Report to the Plan Commission

Legistar I.D. #22831
2705 East Washington Avenue
Conditional Use

Requested Action: The applicant requests approval of a conditional use to allow the construction of a McDonald's restaurant with a drive-up service window at 2705 East Washington Avenue.

EXCERPT FROM:
OLD EAST SIDE MASTER PLAN

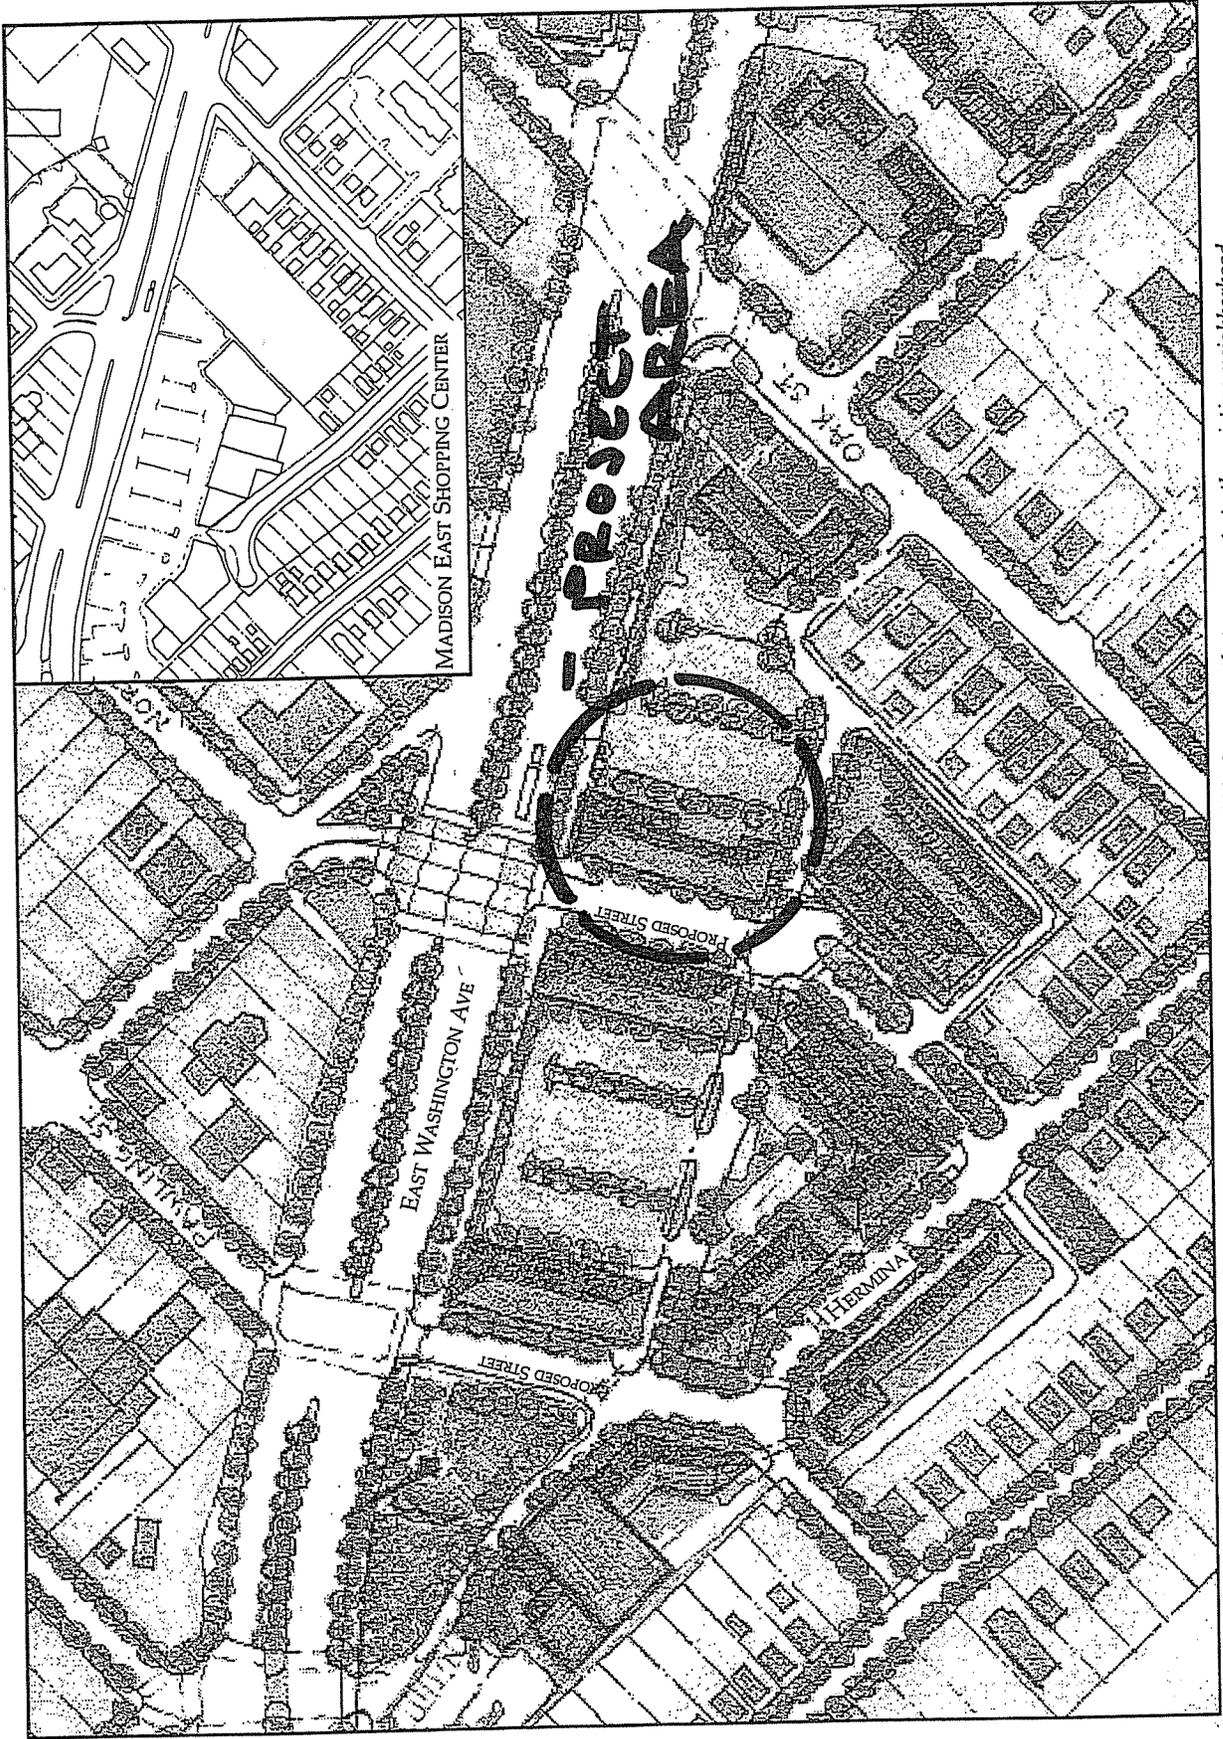
A redeveloped Madison East Shopping Center is based on a street and block pattern that reconnects to the existing neighborhood.
